EB55 – Annotated agenda item 12 (a)(i)

Available to the members of the Board as annex 1 of MP 44 meeting

EB55– Annotated agenda item 16 (a)

EB55 – Annotated agenda item 16 (b)

Common practice analysis in the current ACM0016 (ver 01)

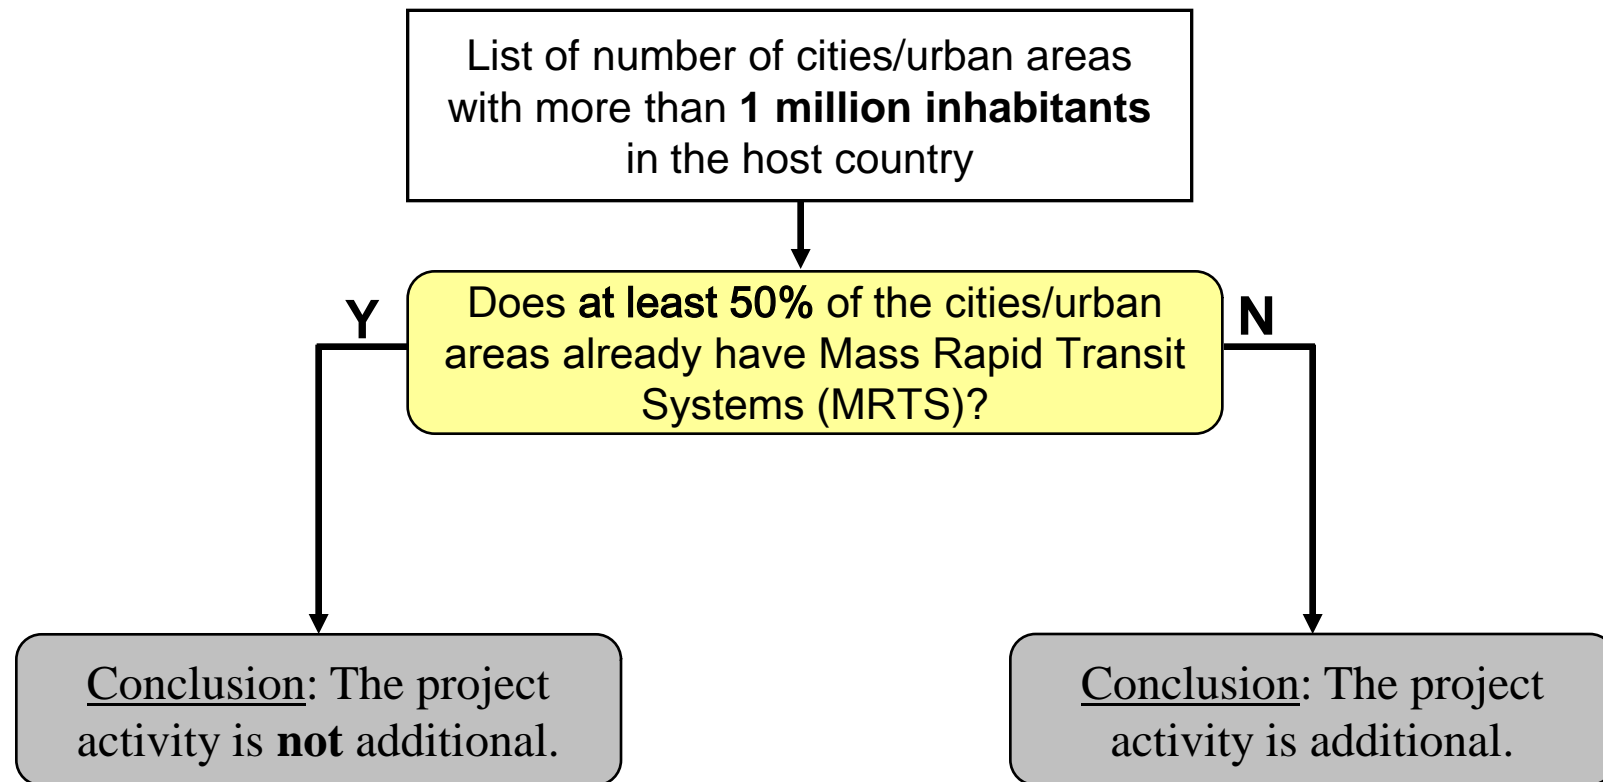
AM_REV_0192 aims to revise the methodology to address situations in which there are no cities with more than 1 million inhabitants in the host country, and thus the common practice analysis cannot be undertaken.
